KOOGLER & ASSOCIATES
ENVIRONMENTAL SERVICES

June 22, 2006

**SUBJECT: Response to 2nd Request for Additional Information (RAI)
Air Construction Permit Application for Clay Shredder System and
Concurrent Title V Air Operation Permit Revision
(DEP Project Nos. ~~1050010-020-AC~~ & ~~1050010-021-AV~~)**

Figure 1- Process Flow Diagram - Shredder and Associated Equipment.
CEMEX USA Inc., Quarry (Revised 06/20/2006)

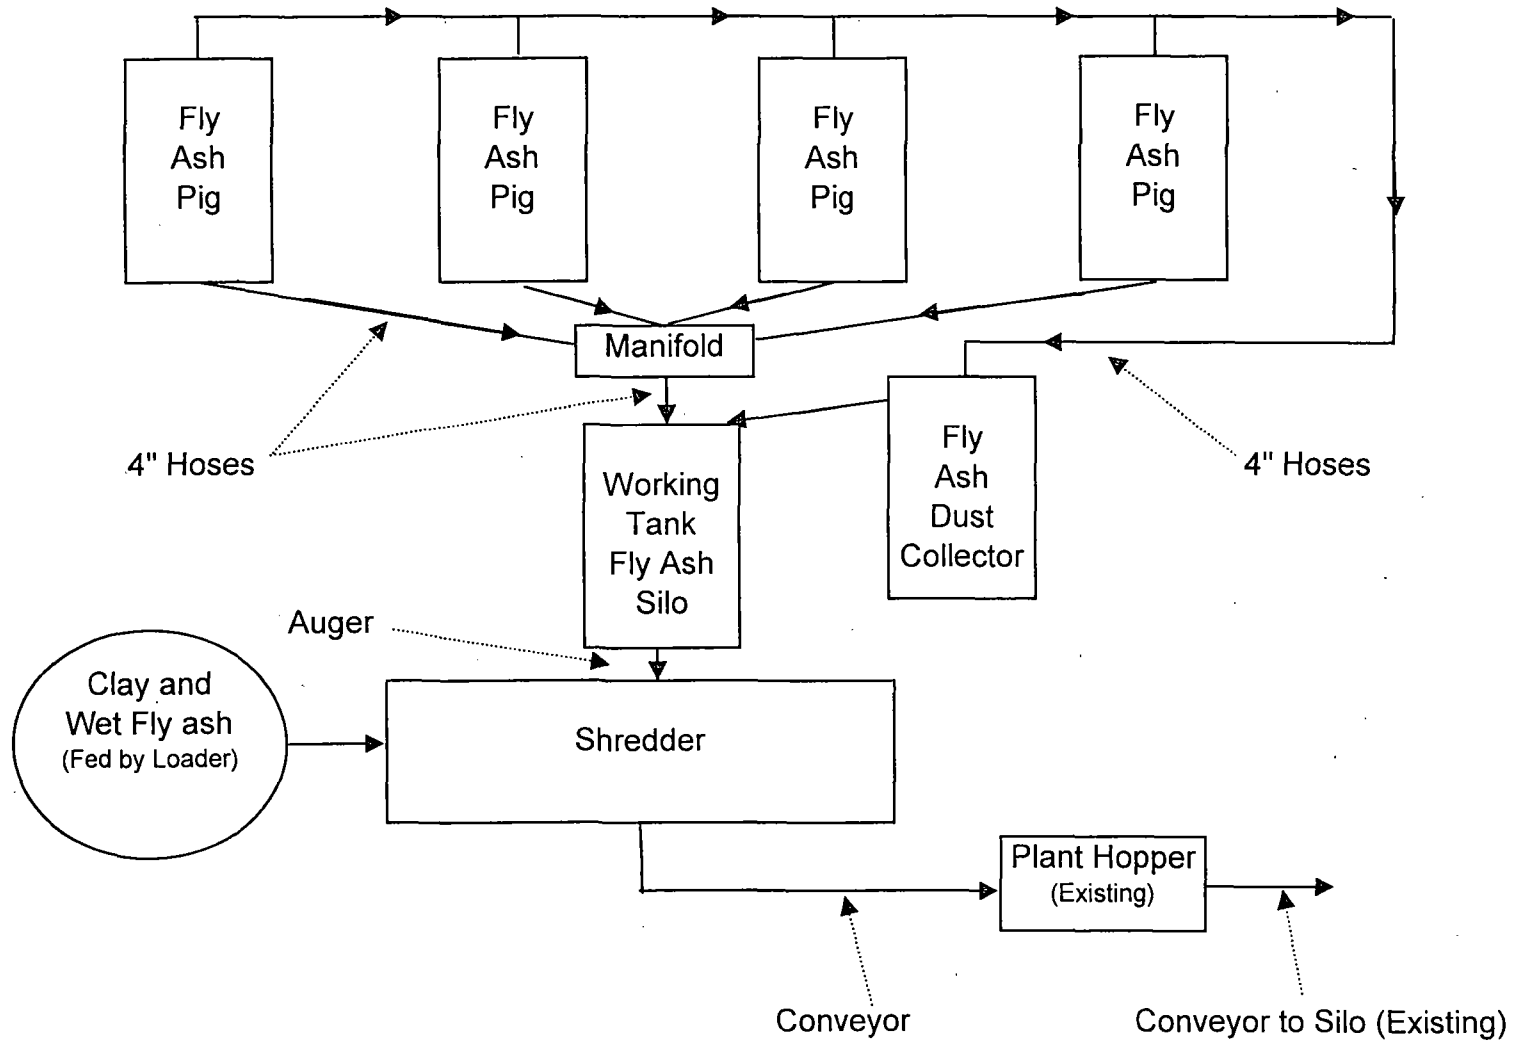
CEMEX request that the permit allow for the addition of *WET* fly ash to the clay shredder system. The wet fly ash would further reduce fugitive emission. Calculations for wet fly ash are included revised Table 1 of Attachment A in this submittal.

Wet clay will be loaded into the shredder hopper and shredded to reduce the clay clumps size to 1" to 3". While shredding the clay, fly ash is added to coat the clay and reduce the moisture level of the mix *in order to reduce process plugging*. Fly ash is also an additive in the cement making process. The mixture, required to reduce the clay to the desired moisture content the will vary from approximately 85% clay and 15% fly ash.

Fly ash is to be delivered to CEMEX and loaded into one of the four "pigs", which store 125 tons of fly ash each. The pig transfer fly ash to the 25 ton storage capacity "working tank" that will meters the fly ash at the required volume to the shredder through a variable speed auger. Potential particulate emissions from fly ash transfers to the pigs and working tank will be controlled by a dust house located atop the working tank. *Wet fly ash may also be utilized and will be added to the clay shredder by means of a front-end loader.*
